WILLIAMSON COUNTY, TEXAS

CHANGE ORDER NUMBER: 1

Project:	<u>T1740</u>
Roadway:	<u>Sam Bass Interim Signals</u>
CSJ Number:

Sam Bass Interim Traffic Signals Williamson County Project No. T1740

WILLIAMSON COUNTY
SAM BASS ROAD
LOAD SWITCH
SAM BASS RD AT GREAT OAKS DR

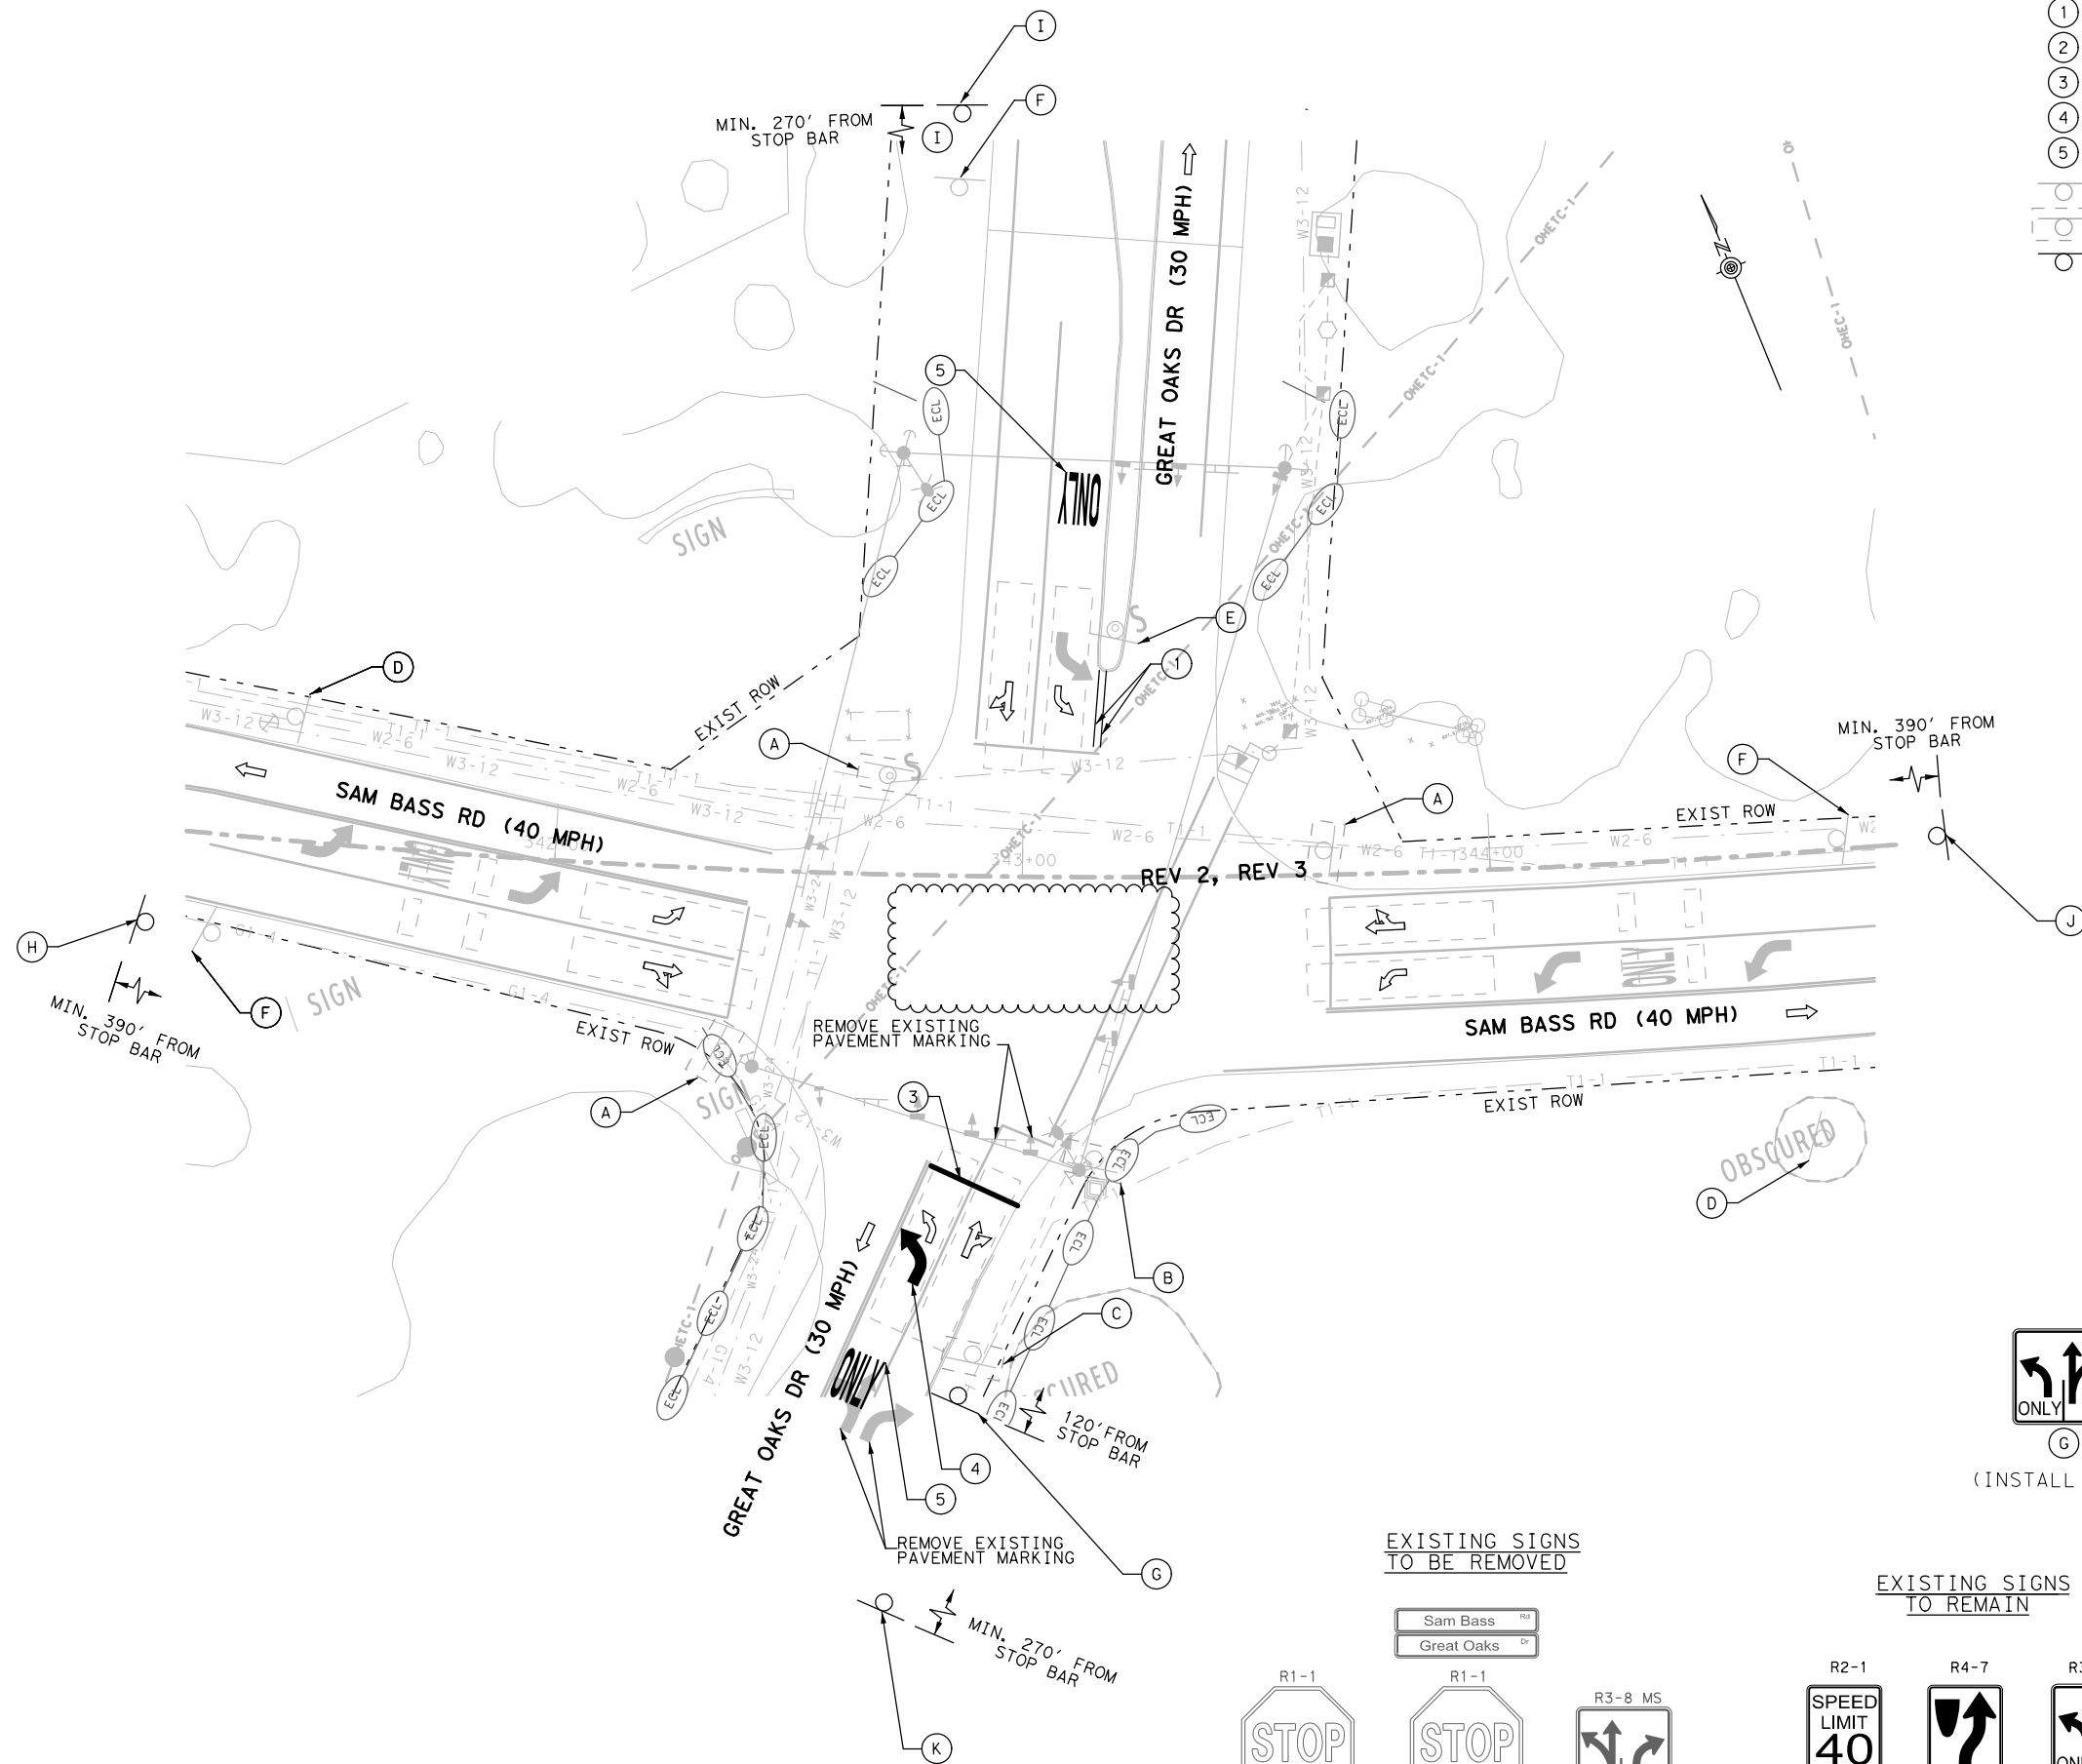
Revision #1: The timber poles on the south side of the intersection of Sam Bass Road and Great Oaks Drive were changed to steel poles with concrete foundations. This change is because there is not enough right of way on the south side to install guy wire support for timber poles.

Revision #2: RFI#7 Adds pedestrian signal elements to maintain the existing cross walk at the intersection of Great Oaks Drive and Sam Bass Road for pedestrian safety.

Revision #3: RFI#8 Changes the location of the signal controller and the electric service at Great Oaks Drive intersection to the northeast corner. The plan locations were in front of a house in the southwest corner and had an aesthetic impact on the adjacent property.
